SUPPLEMENTAL FINDING OF NO SIGNIFICANT IMPACT

Project	Ten Mile Creek Estates/Pleasant Valley County Sewer District
Location	Helena, Montana
Project Number	WPCSRF #: C301268
Original Cost	\$5,633,275.00
Revised Cost	\$6,313,700.00

AMENDED FIGURE 3 ALTERNATIVE T-2
TOTAL RETENTION SYSTEM (RECOMMENDED - PHASE 3)

TEN MILE/PLEASANT VALLEY WASTEWATER SYSTEM IMPROVEMENT PROJECT
TEN MILE ESTATES SEWER DISTRICT

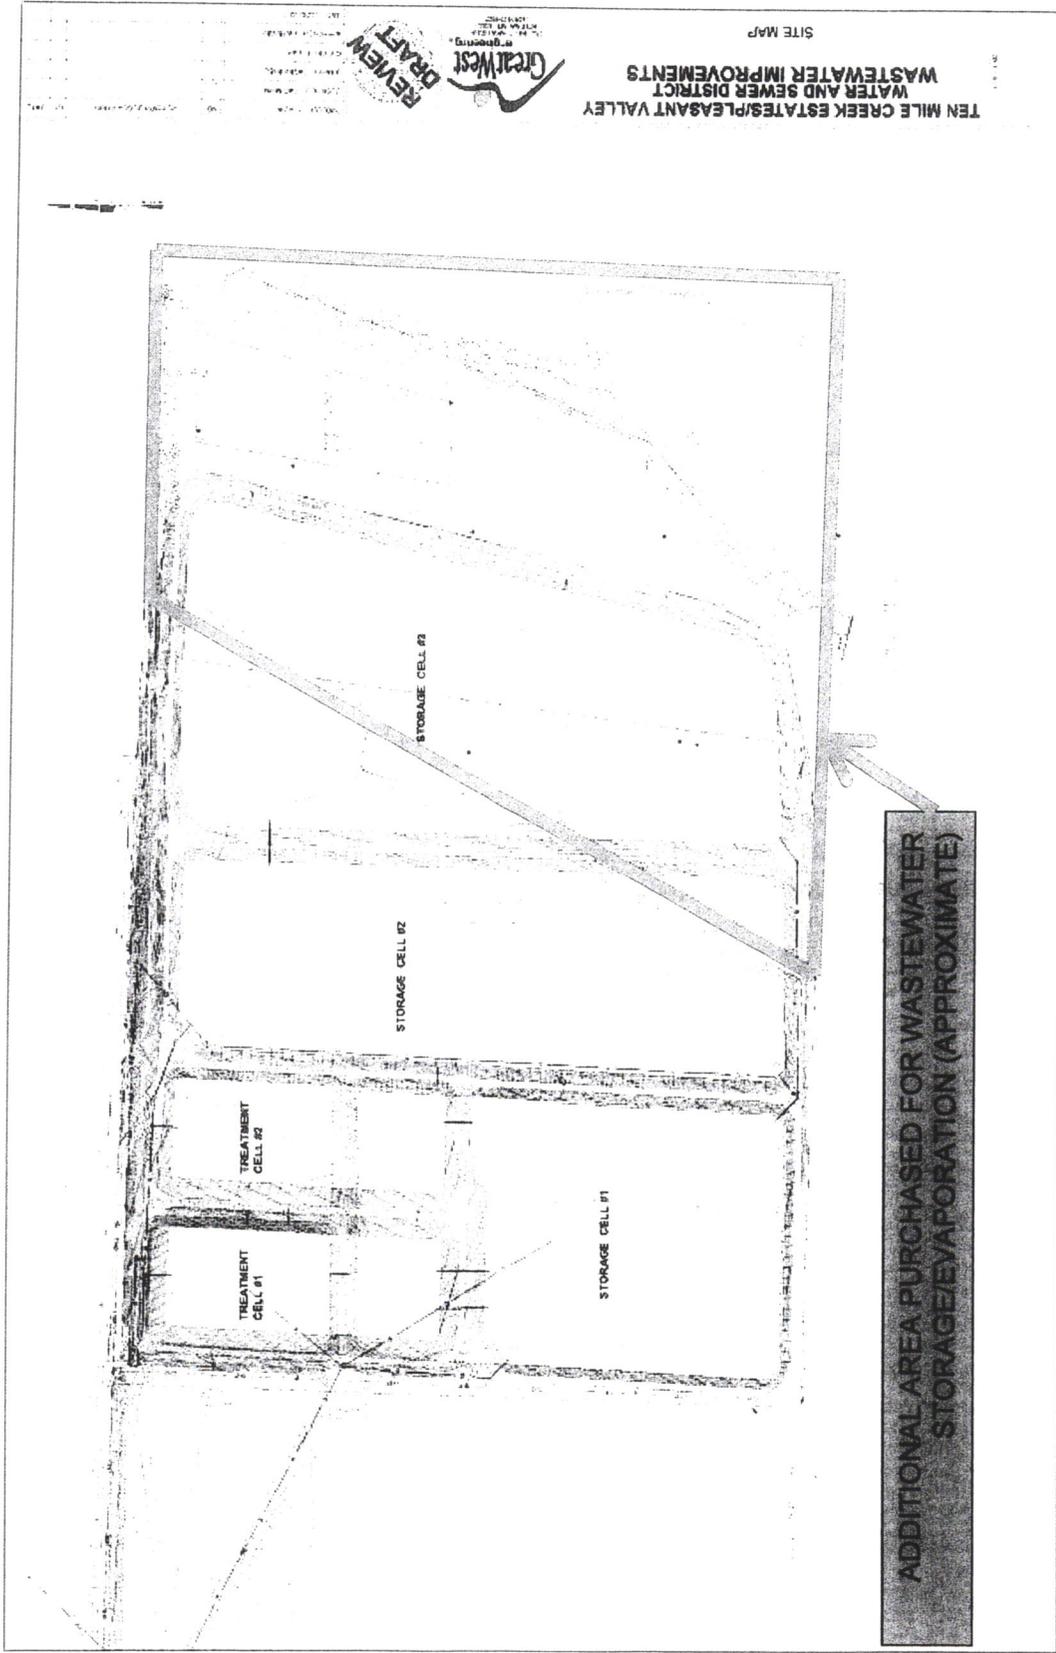
Monitoring of the wastewater flow from the Ten Mile Estates and Pleasant Valley subdivision has been occurring since the spring of 2013 and the average day flow was determined to be higher than previously anticipated. The higher wastewater flow required the design engineer to incorporate a change in the design that required about 15 acres of additional storage/evaporation area. A 30 acre site adjacent to the existing lagoons was purchased recently by the Ten Mile Estates County Sewer District (District) to provide the necessary storage/evaporation area. About 5 acres of the additional area will be used as a gravel borrow source to construct the proposed treatment system, eliminating the need to haul gravel to the site as originally proposed. Although the flow volume is larger, the recommended treatment system will remain a total retention system.

Except for the changes noted above, all aspects and conclusions made in the August 29, 2013 Environmental Assessment (EA) remain accurate. The August 29, 2013 EA and an Amended Site Plan (Figure 3 in the EA) are available for public scrutiny on the DEQ web site (<http://www.deq.mt.gov/ea.mcp>) and at the following locations:
